PROPOSED CHANGE RTS-131
TO
DUANE ARNOLD ENERGY CENTER
TECHNICAL SPECIFICATIONS

The holders of License DRP-49 for the Duane Arnold Energy Center propose to amend Appendix A (Technical Specifications) to said license by deleting current pages and replacing them with the attached new proposed pages. A list of the affected pages is included.

Duane Arnold Energy Center
 Iowa Electric Light and Power Company
 Technical Specifications
 DAEC Nuclear Plant Staffing
 Figure 6.2-1

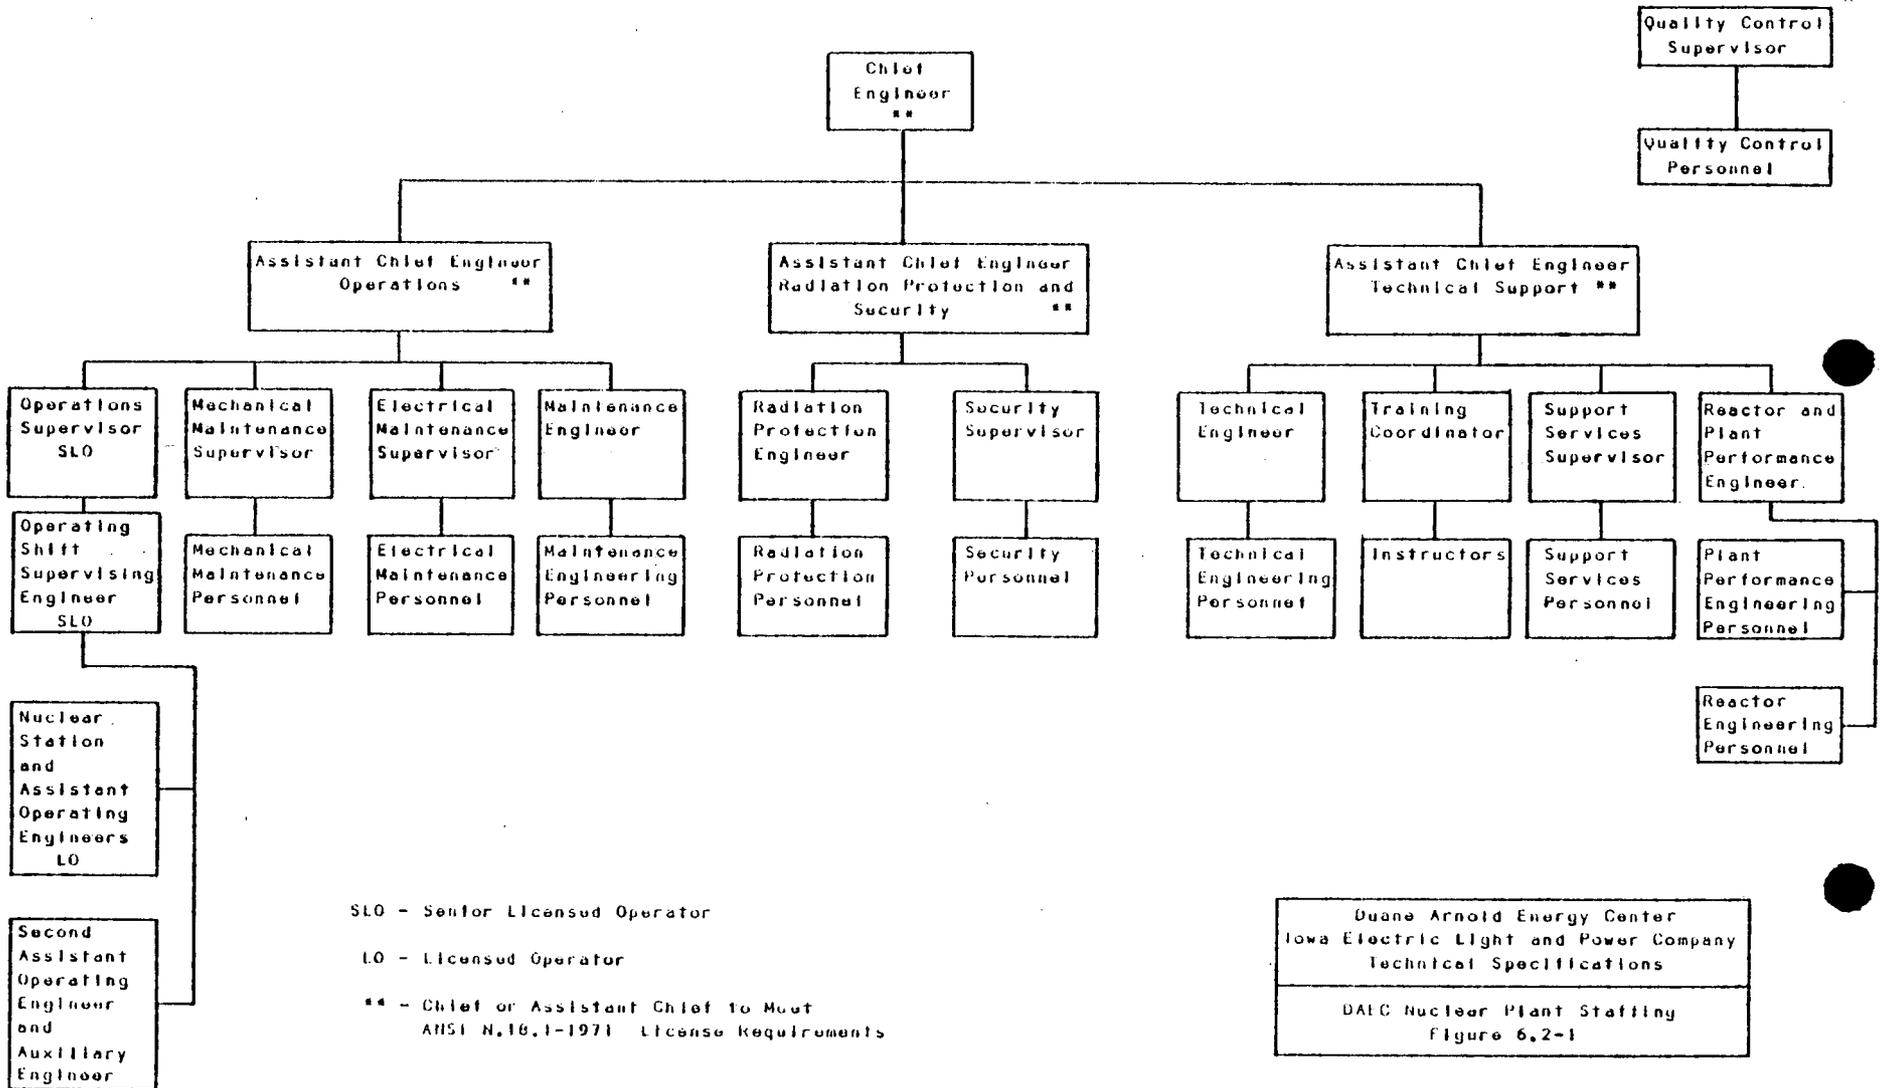
- (1) Section 6.5 is revised to reflect that the Safety Committee shall be appointed by and report to the Executive Vice President, and that appropriate records shall be forwarded to the Executive Vice President.
- (2) Figure 6.2-1 is revised to reflect the DAEC Nuclear Plant Staffing Organization consisting of division of activities with three Assistant Chief Engineers.
